Item ID: D407-667-205TRN Accept ***N900040100*** Setup Start ***NS1***
 Revision ID: Stop ***NS2***
 Item Name: Crosstube Turning Detail
 Start Date: 18/10/2011 Start Qty: 1.00 ***1*** Cust Item ID:
 Required Date: 07/11/2011 Req'd Qty: 1.00 ***1*** Customer:
 Reference:

DART AEROSPACE LTD	Work Order: 75146
Description: Crosstube Assembly	Part Number: D407-667-245
Inspection Dwg: D407-667-245 Rev: F	Page 1 of 1

DRAWING NO. D407-667-245	TITLE CROSSTUBE ASSY (407 HIGH AFT)	REV. F	DART AEROSPACE LTD ENGINEERING ORDER		D.E.O. NO. D407-667-245-F-1	SHEET NO. SHEET 1 OF 2	SCALE NTS
DRAWN <i>1</i>	CHECKED <i>40</i>	MFG. APPR. <i>E</i>	APPROVED <i>140</i>		DE APPR. <i>H</i>		
DATE 11.04.08	DATE 11.04.12	DATE 11.04.12	DATE 11.04.12		DATE 11.04.12	DATE 11.04.12

DRAWING NO. D407-667-245	TITLE CROSSTUBE ASS'Y (407 HIGH AFT)	REV. F	DART AEROSPACE LTD ENGINEERING ORDER		D.E.O. NO. D407-667-245-F-2	SHEET NO. SHEET 1 OF 1	SCALE NTS
DRAWN <i>q</i>	CHECKED <i>ASS</i>	MFG. APPR. <i>E</i>	APPROVED <i>MP</i>		DE APPR. <i>th</i>		
DATE 11.09.07	DATE 11.09.19	DATE 11.09.19	DATE 11.09.19		DATE 11.09.19

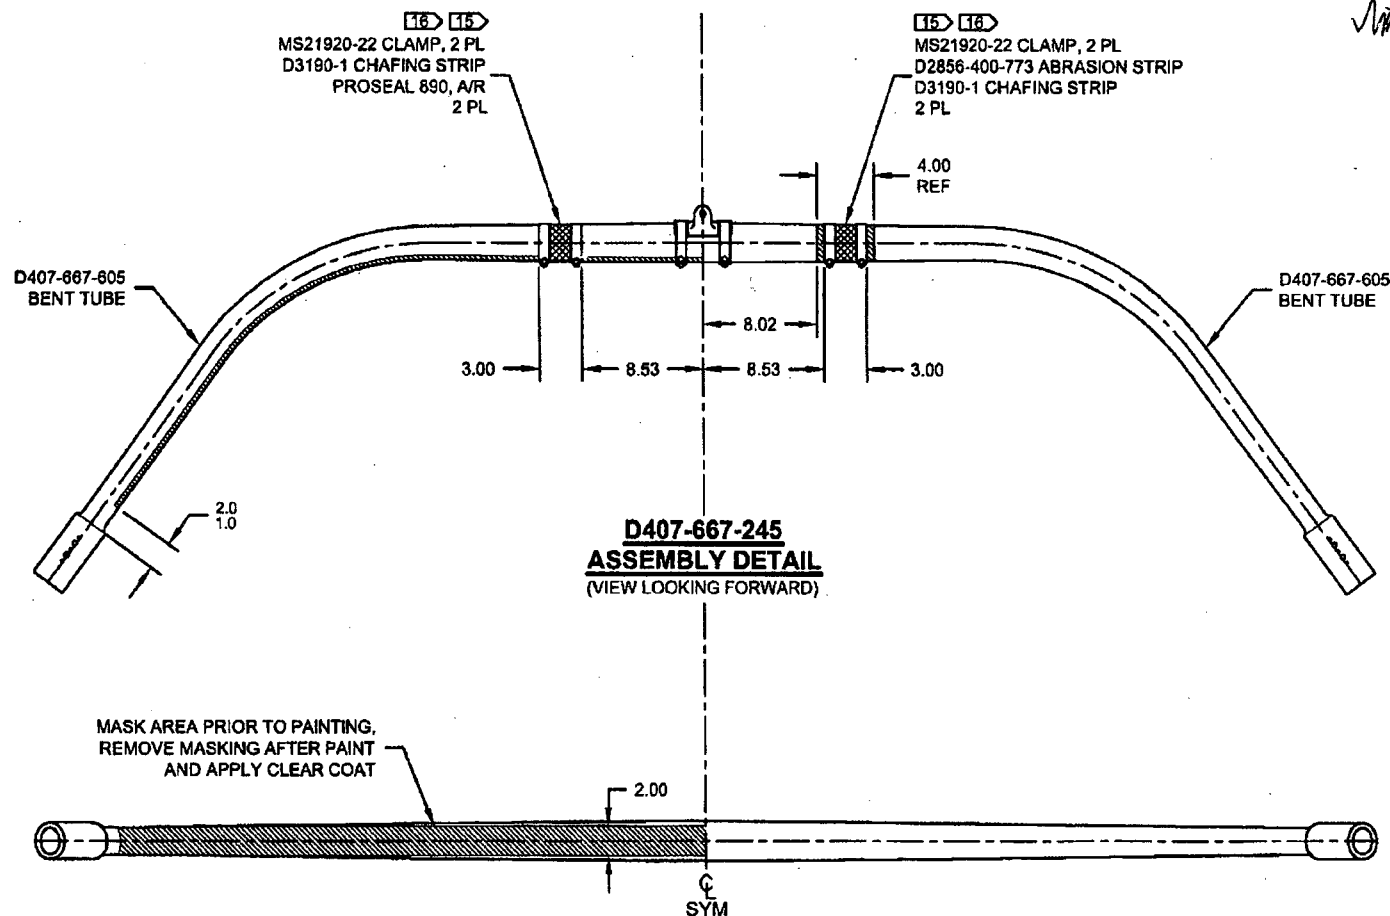
PURPOSE:

REMOVED ABRASION STRIP IN FAVOR OF A THIN LAYER OF PROSEAL 890.

IS:

WAS:

- 2) FINISH: CHEMICAL CONVERSION COAT PER DART QSI 005 4.1
PRIME INSIDE AND OUTSIDE PER DART QSI 005 4.2
MASK UNDERSIDE OF CROSSTUBE AS SHOWN (HATCHED AREA) AND
PAINT OUTSIDE PER DART QSI 005 4.2
REMOVE MASKING AND APPLY CLEAR COAT
- 15) APPLY A THIN COAT OF PROSEAL 890 ON INSIDE CONCAVE SURFACE OF D3190-1
CHAFING SHIELDS AND LET CURE PER MANUFACTURER'S INSTRUCTIONS. INSTALL
PROSEALED D3190-1 CHAFING SHIELDS ONTO CROSSTUBE BY APPLYING A THIN COAT
OF PROSEAL 890 ONTO CROSSTUBE. BE SURE TO ELIMINATE ANY AIR GAPS.
